## Town of Franklin

**DATE:** May 7, 2020  
**TO:** Franklin Planning Board  
**FROM:** Department of Planning and Community Development  
**RE:** 158 Grove Street  
Special Permit & Site Plan Modification

# SITE PLAN MODIFICATION 70, 72, 88 AND 94 EAST CENTRAL STREET

**Re: 70, 72, and 94 East Central Street  
Site Plan Peer Review Update**

DATE	MAR. 4, 2020
SCALE	1" = 20'
PROJECT	UC1334
SHEET	3 of 9

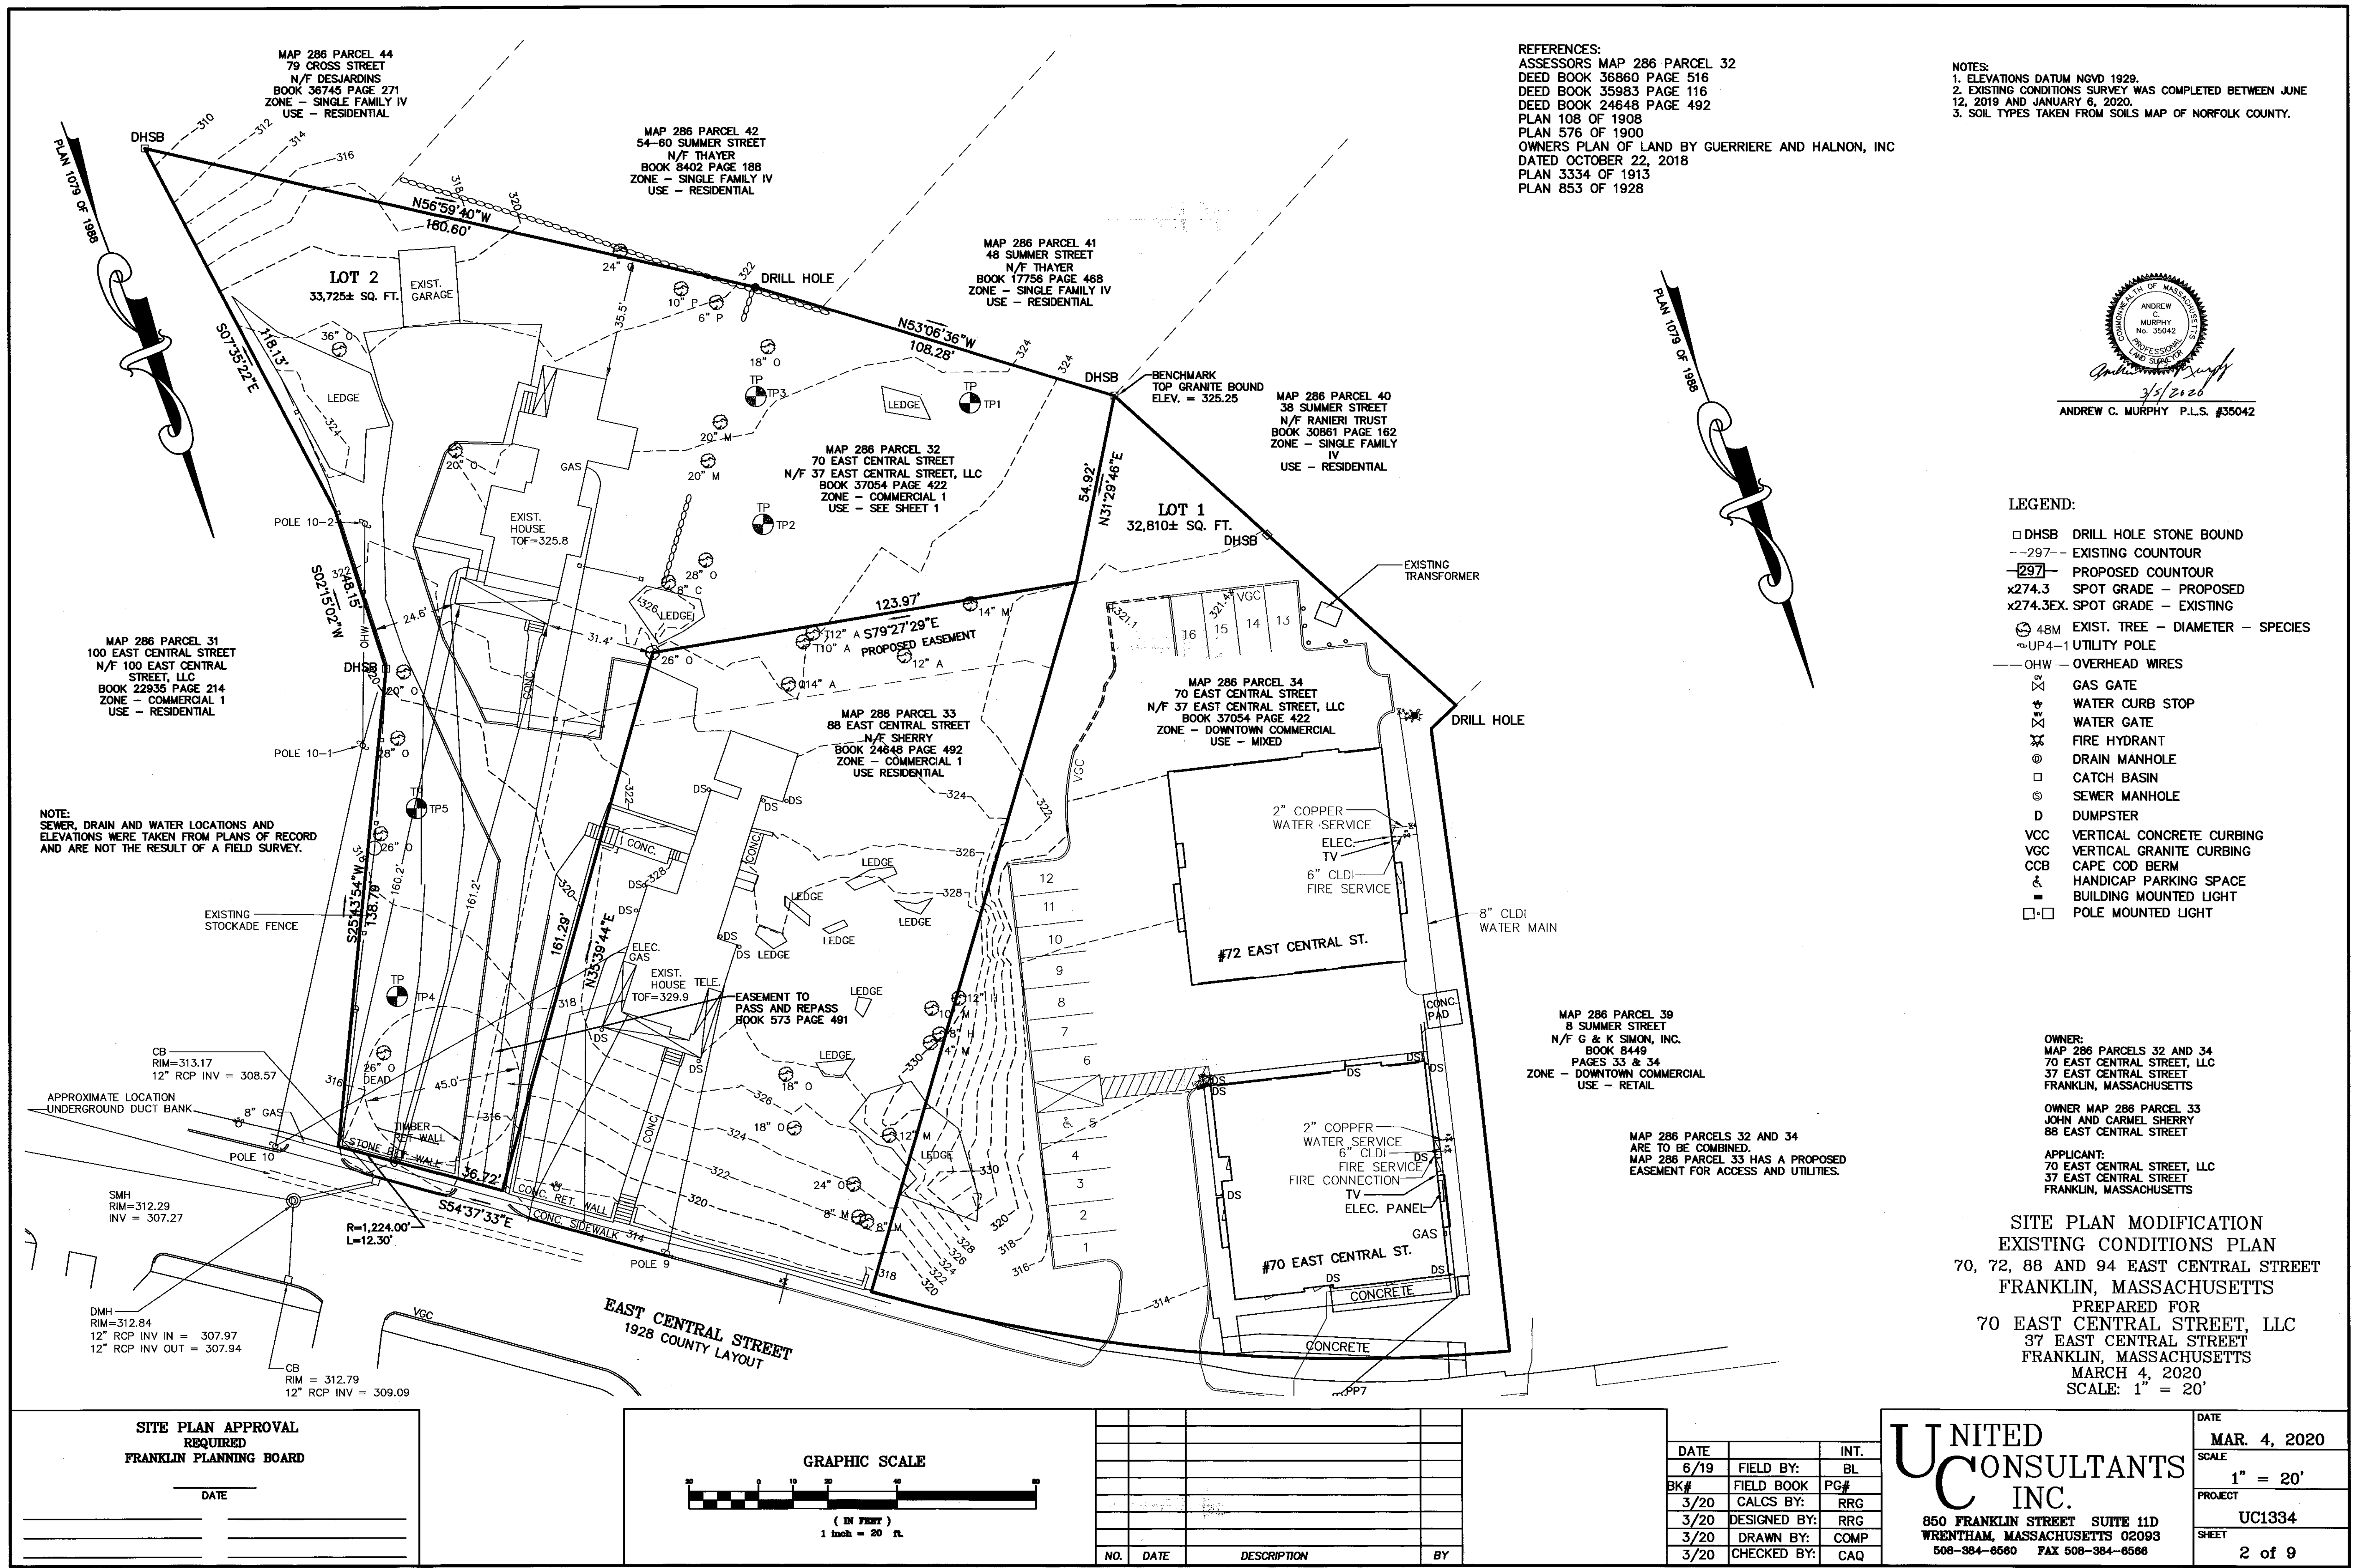
- SCH4. Recommend removing the redundant Zoning Legend on Sheet 3. *UCI: Zoning legend has been removed.* **BETA2: Plan revised – issue resolved.**

- P2. Revise the proposed easement across the #88 East Central Street property to maintain at least 24 feet continuously from the proposed southerly/easterly curb line. *UCI: The proposed easement has been revised on sheet 3. BETA2: Easement revised – issue resolved.*

- P9. The proposed development will result in the loss of two parking spaces on the adjacent #70/#72 East Central Street property. The designer should confirm the proposed number of spaces will comply with the current Bylaw. *UCI: Refer to parking schedule on sheet 3. BETA2: Information provided – issue resolved.*

**SITE PLAN MODIFICATION  
PLANTING PLAN**  
70, 72, 88 AND 94 EAST CENTRAL STREET  
FRANKLIN, MASSACHUSETTS  
PREPARED FOR  
70 EAST CENTRAL STREET, LLC  
37 EAST CENTRAL STREET  
FRANKLIN, MASSACHUSETTS  
MARCH 4, 2020  
SCALE: 1" = 20'

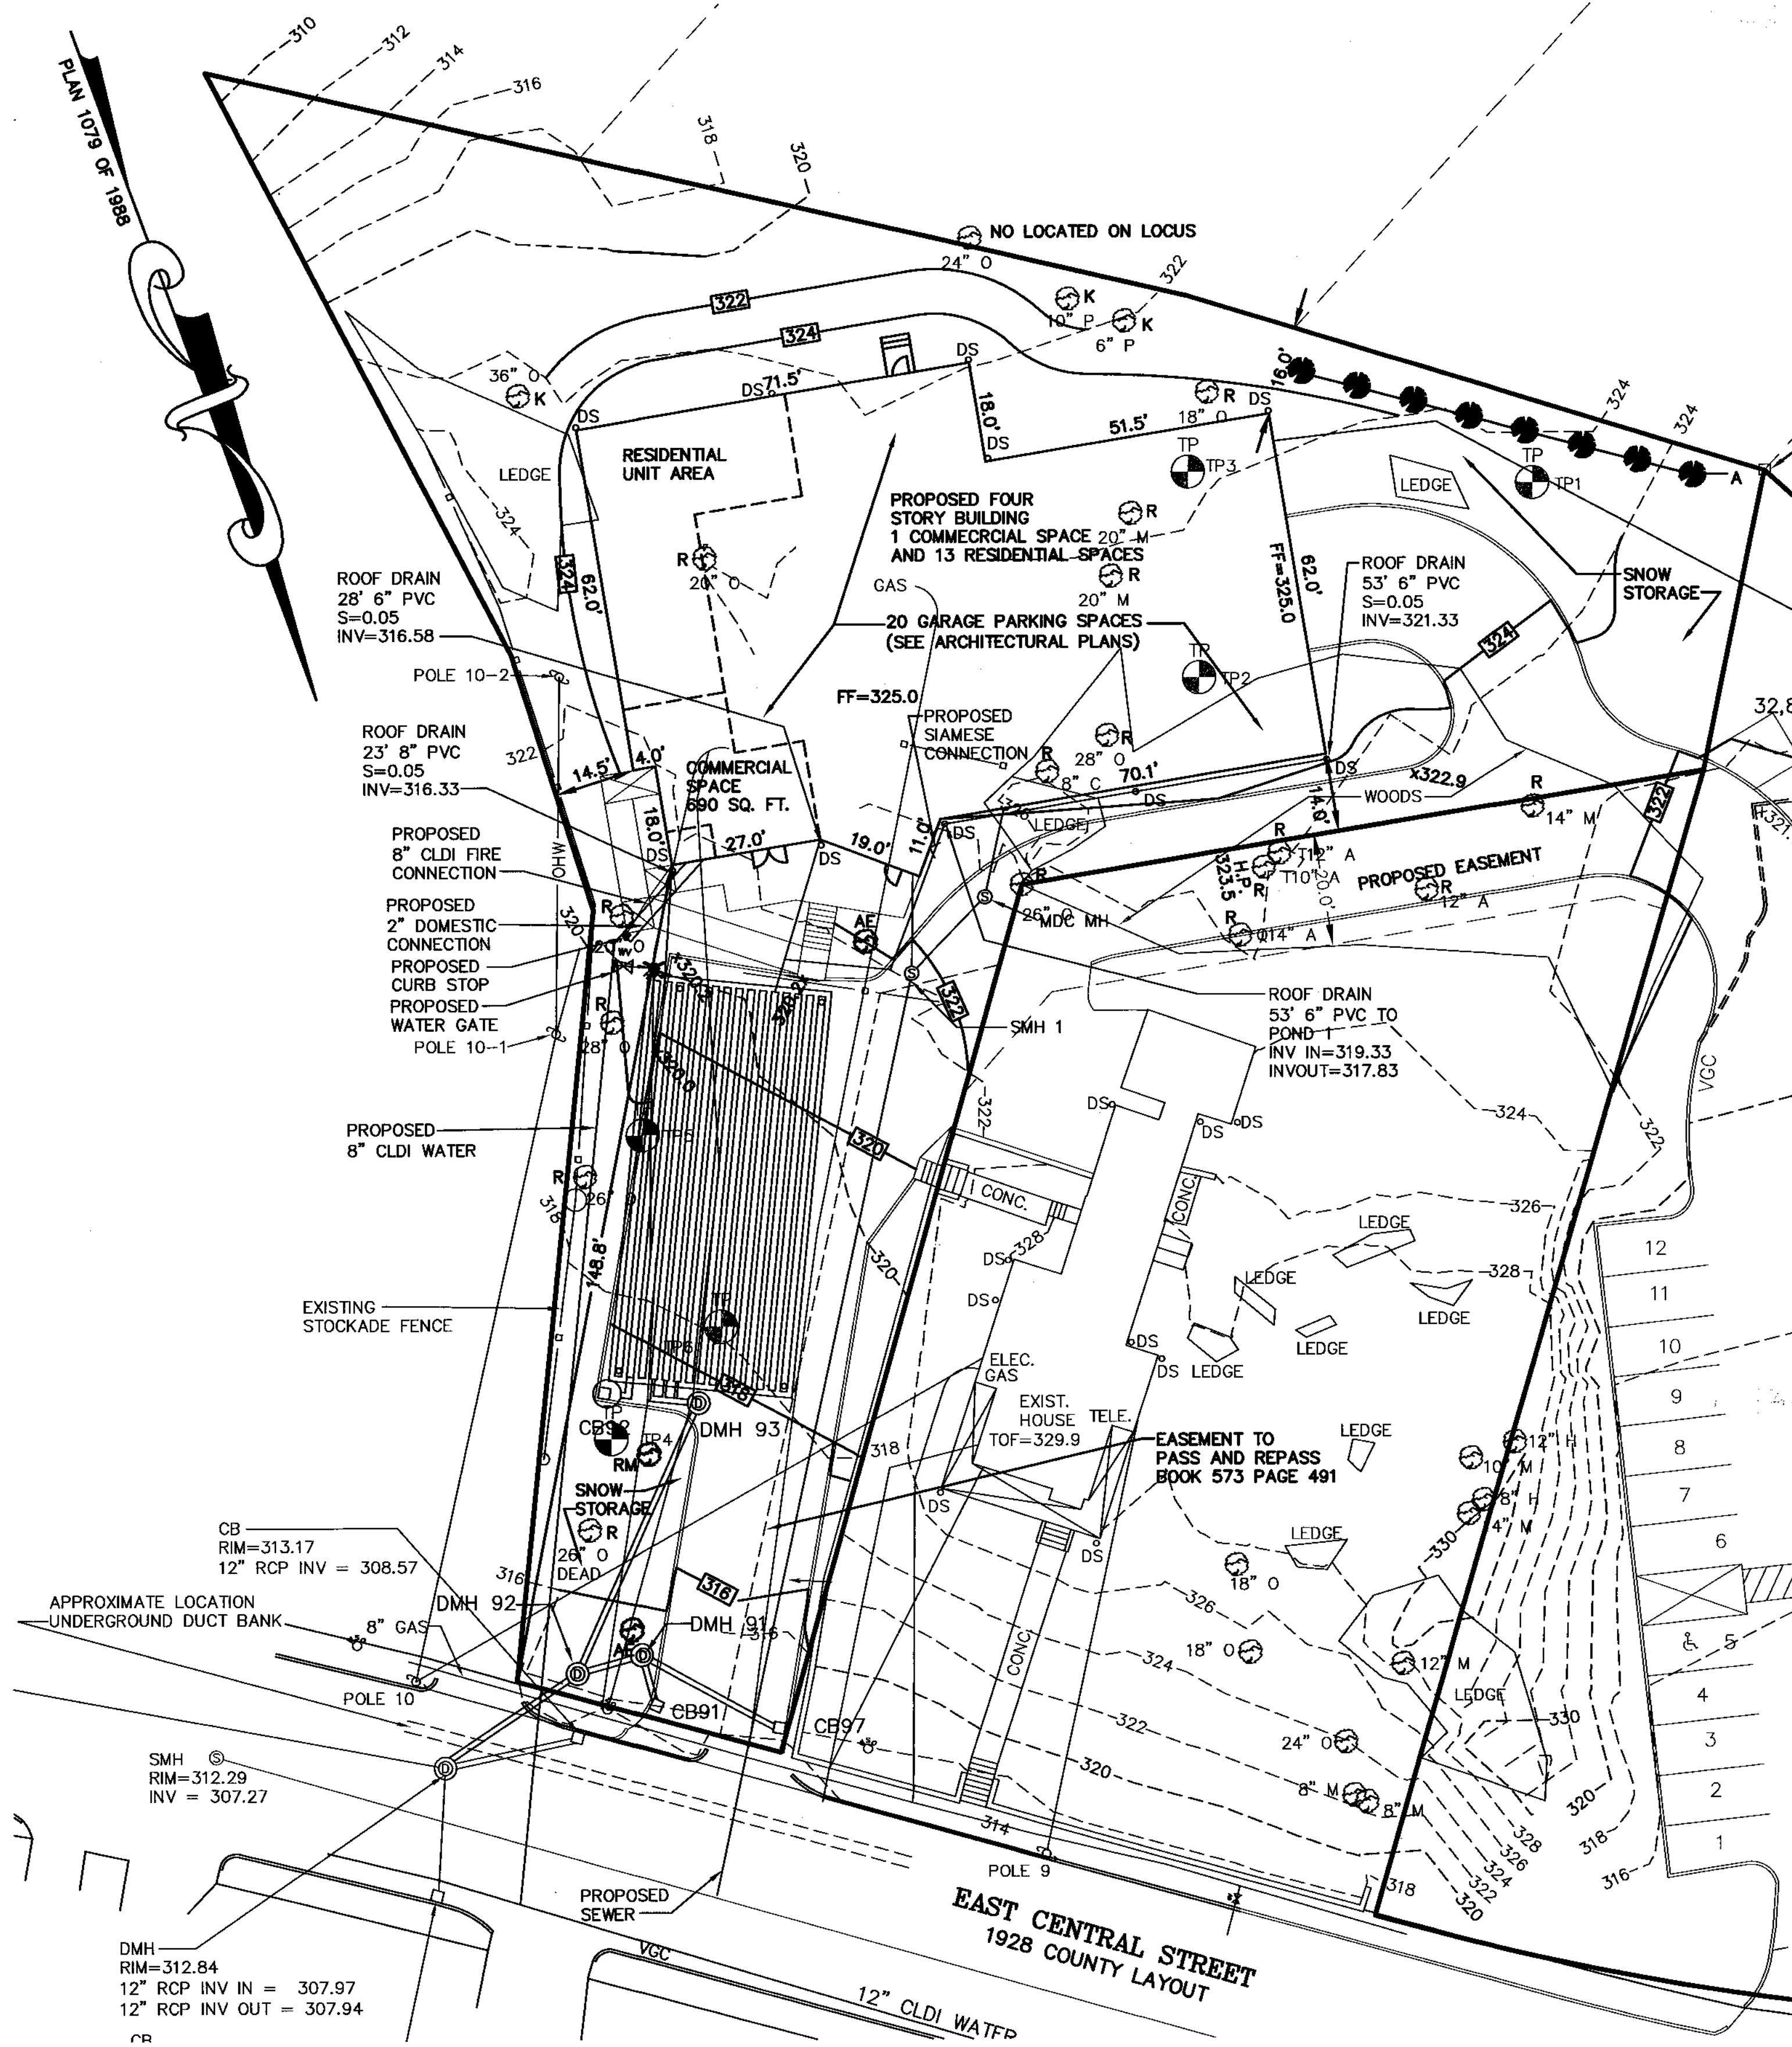
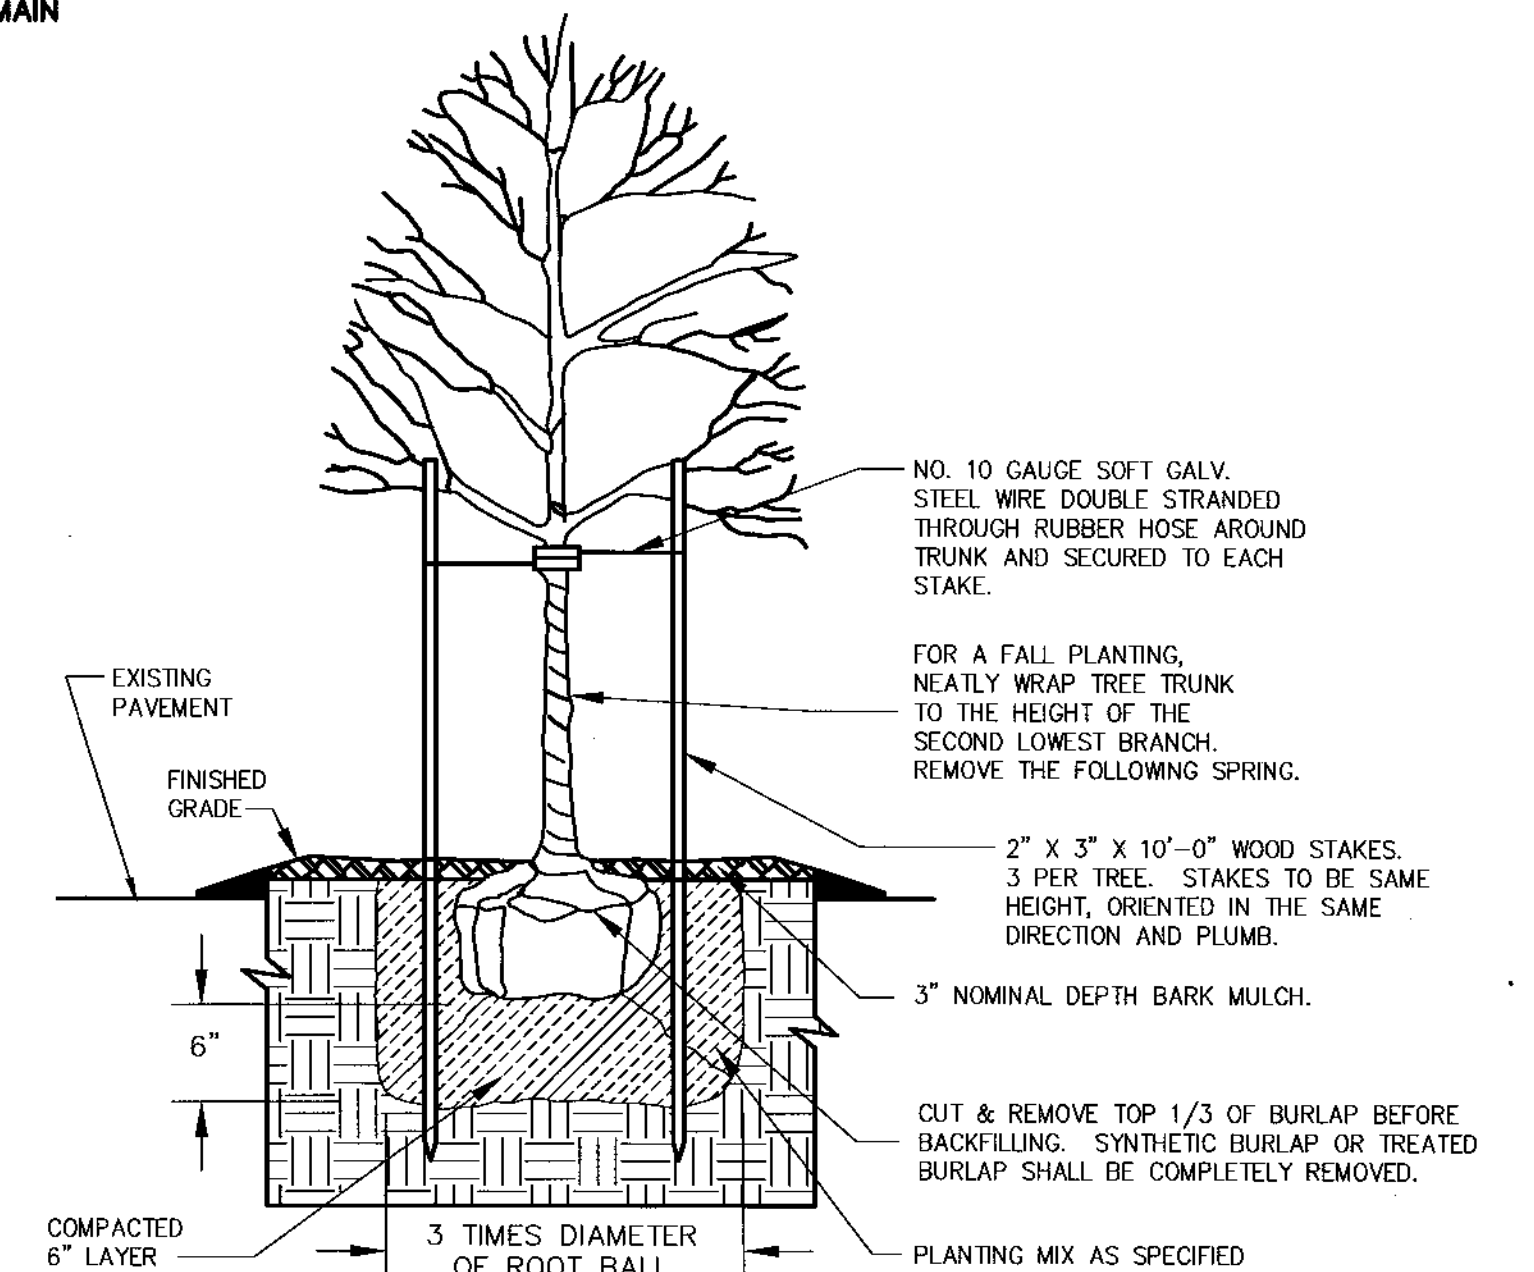
- G3. Clarify the disposition of existing site features, including but not limited to, trees, stone retaining walls, utility pole 10-2, and stockade fence. *UCI: The disposition of the stone retaining wall, existing utility services and pole 10-2 have been added to sheet 4. The existing fence along the 94 – 100 East Central Street property boundary is proposed to remain. The disposition of the existing site trees has been added to sheet 5.* **BETA2: Information provided – issue resolved.**

SITE PLAN MODIFICATION  
EROSION CONTROL PLAN  
70, 72, 88 AND 94 EAST CENTRAL STREET  
FRANKLIN, MASSACHUSETTS  
PREPARED FOR  
70 EAST CENTRAL STREET, LLC  
37 EAST CENTRAL STREET  
FRANKLIN, MASSACHUSETTS  
MARCH 4, 2020  
SCALE: 1" = 20'

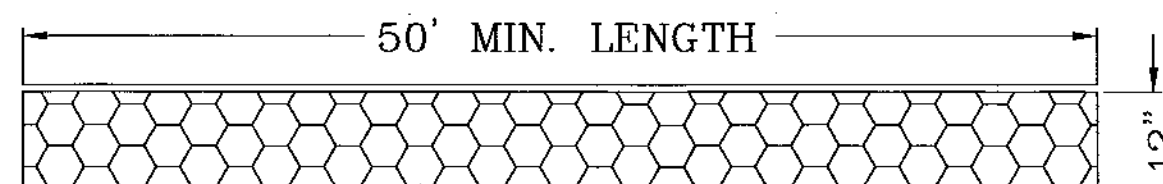
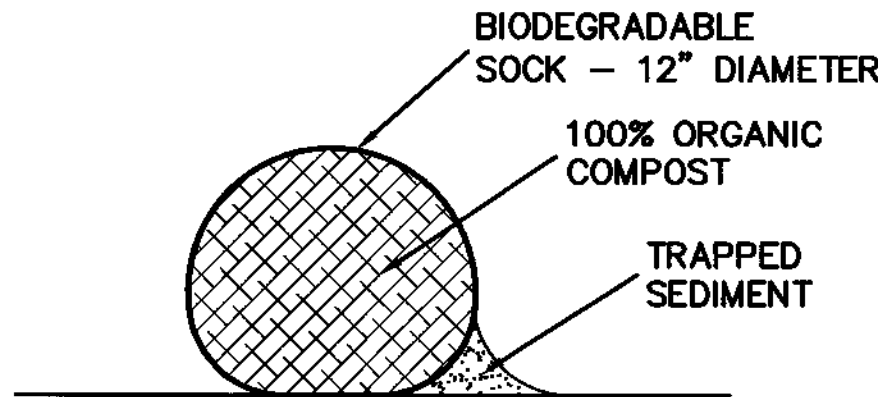
SW15. Provide erosion and sedimentation controls near the westerly property line and/or at the #70/#72 East Central Street property. *UCI: Additional erosion control barriers have been added to sheet 6.* **BETA2: Additional controls provided – issue resolved.**
